Appeal NO: ACP-323120-25Defer Re O/H ☐Having considered the contents of the submission dated 29/09/25 received fromSt. Lawrence O Toole Trust recommend that section 131 of the Planning and Development Act, 2000 ☒ be not be invoked at this stage for the following reason(s): new planning material receivedE.O.: Laura Goady LawlorDate: 02/10/25

Re: Third Party Appeal- Dublin City Council – Notification of as Decision to Grant Permission for construction of an office building up to 14 storeys in height over a double basement including arts and cultural spaces; associated car and bicycle parking; all ancillary and associated works to facilitate the development at 1-4 City Quay, 5 City Quay and 23-25 Moss Street, Dublin 2

3rd Party Commentary On 1st Party Response to Appeal Daylight and Sunlight Assessment

26 Sept 2025

Distance Assessment

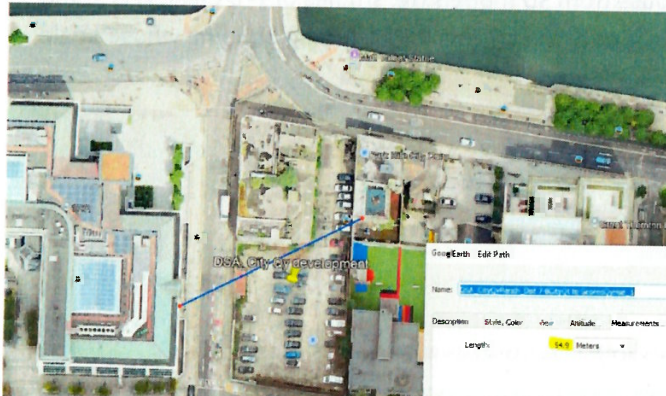
Distance paths to scale on Google Earth (see measurements in metres on images):

- 1 Return 7-8 City Qy (it's nearest point) to Georges Qy House (along shortest line)

2. Main block of 7-8 City Qy to Georges Qy House (along most unobstructed line)

3 return of 7-8 City Qy to Georges Qy House (along most unobstructed line)

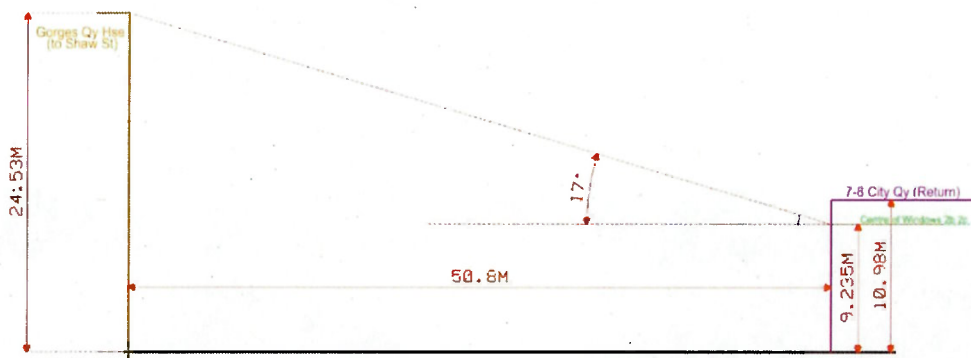
1 Angle between windows on 7-8City Qy's return (nearest) and parapet of Georges Qy House along shortest line is 17 degrees ie significantly less than 25 degrees.

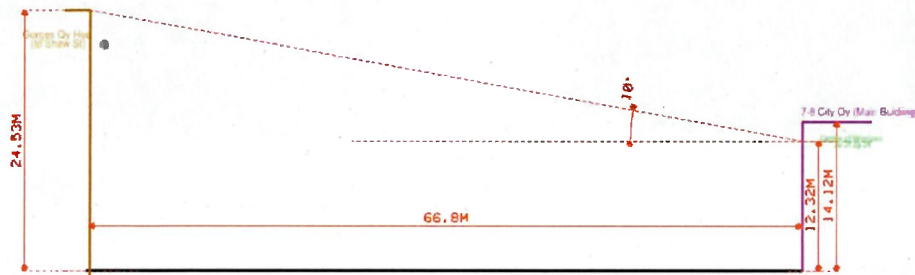
2 Angle between top storey windows (main block of 7-8 City Qy) and parapet of Georges Qy House along most unobstructed line is 10 degrees ie significantly less than 25 degrees.

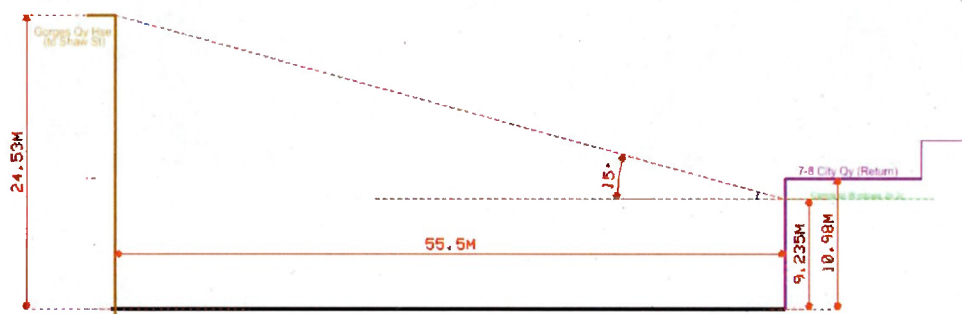
3 Angle between 2nd storey windows (return of 7-8 City Qy) and parapet of Georges Qy House along most unobstructed line is 15 degrees ie significantly less than 25 degrees

2 Overshadowing

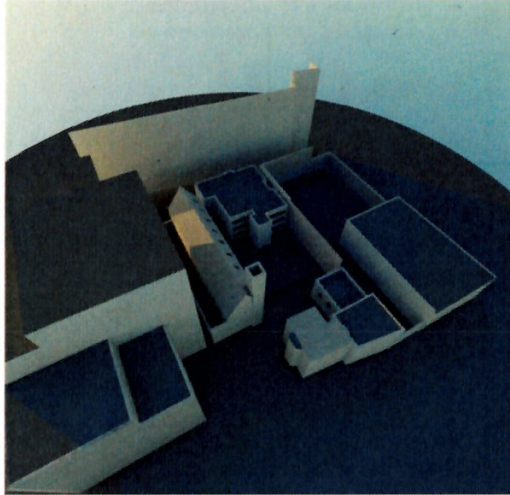
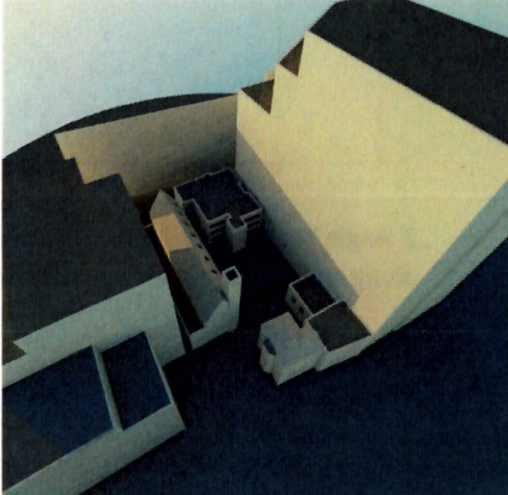
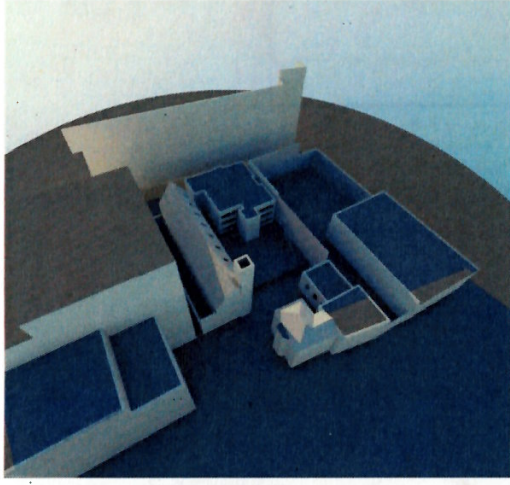
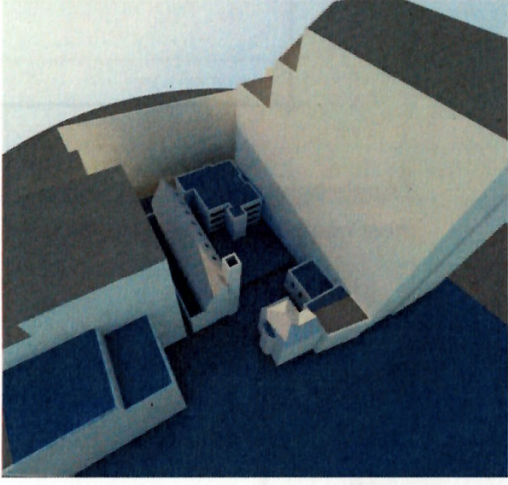
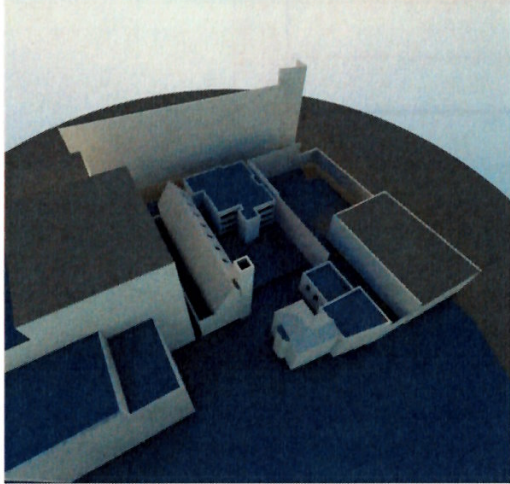
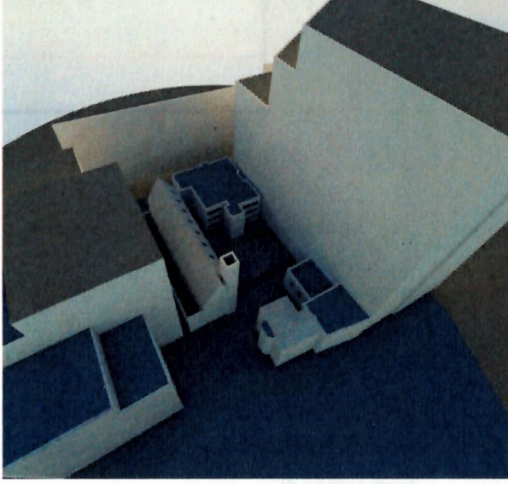
- The applicant has pointed out that in the shadow diagram there is a discrepancy in 2 of 14 image set between the before and after shadow directions which should be the same. They suggest that because of this the model is flawed and comparison impossible. We accept that two images were incorrectly inserted in the table. A balanced review of all other image set however shows that the models are consistent. This error is one of presentation not of assessment and does not call into question in any substantive way the finding of this part of the report. These images have been corrected and are included in the updated table in the Appendix below.

The shadow diagrams hereunder illustrate the affect before and after the development on sunlight access to the schoolyard on various key dates and times throughout the year. (Corrected images highlighted)
